PROJECT NUMBER: AD03-HUL-ACD-08-DR-A-P1018
 PROJECT: ADMSTOWN STATION BLOCKS ACD
 CLIENT: QUINTEAN IRELAND LTD.
 DATE: 08/06/22
 DRAWN BY: [Name]
 CHECKED BY: [Name]
 PROJECT NUMBER: AD03-HUL-ACD-08-DR-A-P1018
 PROJECT: ADMSTOWN STATION BLOCKS ACD
 CLIENT: QUINTEAN IRELAND LTD.
 DATE: 08/06/22
 DRAWN BY: [Name]
 CHECKED BY: [Name]

ISSUED FOR FURTHER INFORMATION

HLL Drawing Number on previously lodged planning application: SP222A/0005
 AD03-HUL-ACD-ZZ-DR-A-P1018 Revision (P01)

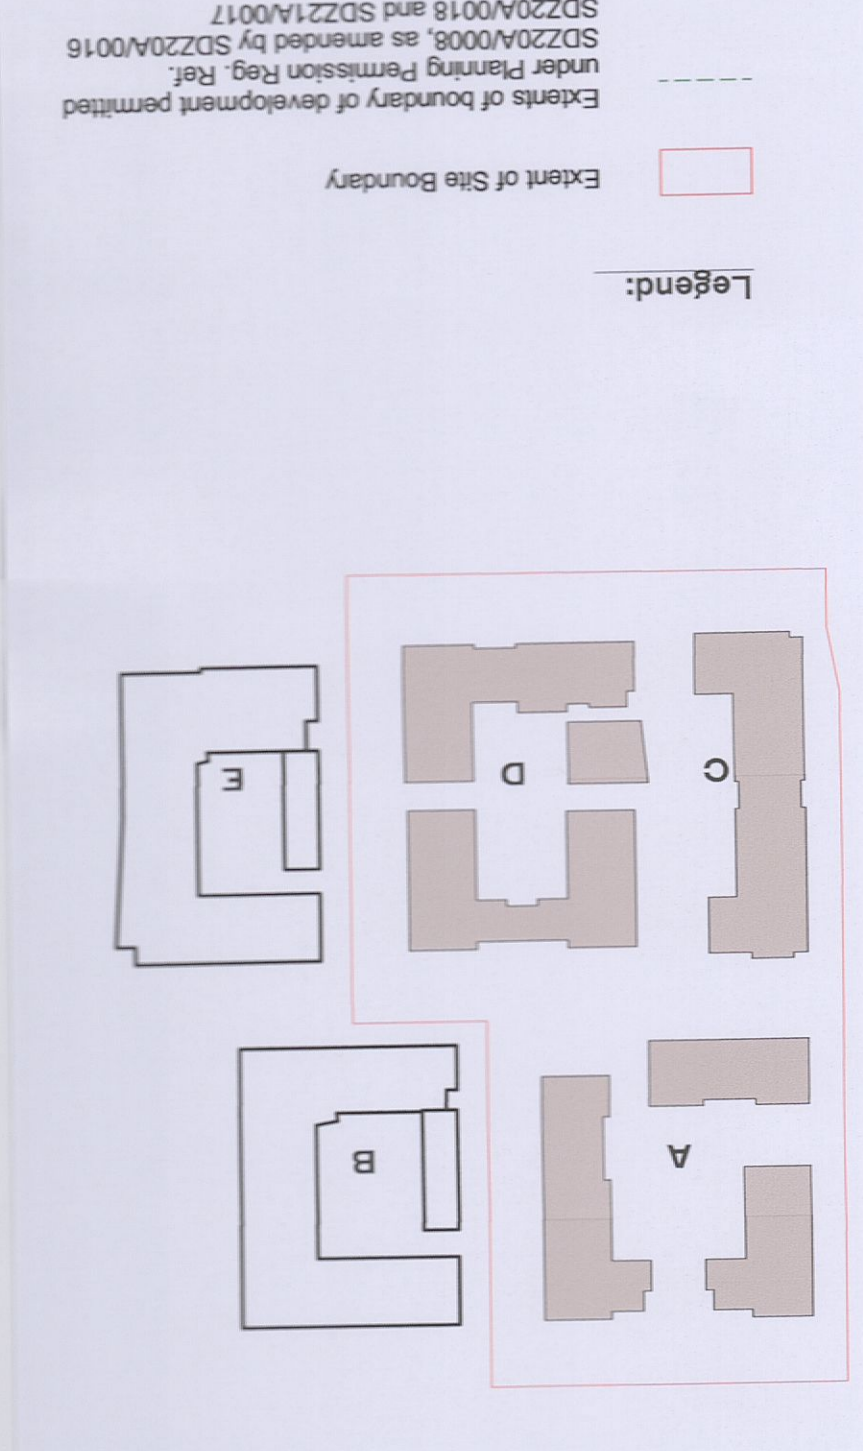
CORRIDOR SHORTENED TO SATISFY FIRE REQUIREMENTS - ELEVATION NOT AFFECTED

PAVILION DESIGN LAYOUT CHANGES DUE TO DESIGN DEVELOPMENT

RFI 1 (a) - Changes to Core entrance hall facing Western Way updated to accommodate new apartment type T_201.D revised apartment type T_102.D and T_202.D to overcome privacy/overlooking issues.
 RFI 1 (b) - Changes to apartment type T_201.D and T_202.D to overcome privacy/overlooking issues.
 RFI 2 - Changes to facade material to brick on the upper floor levels.
 Red dash line indicates extent of amendments to address RFI 0725 dated 08 JUNE 2022
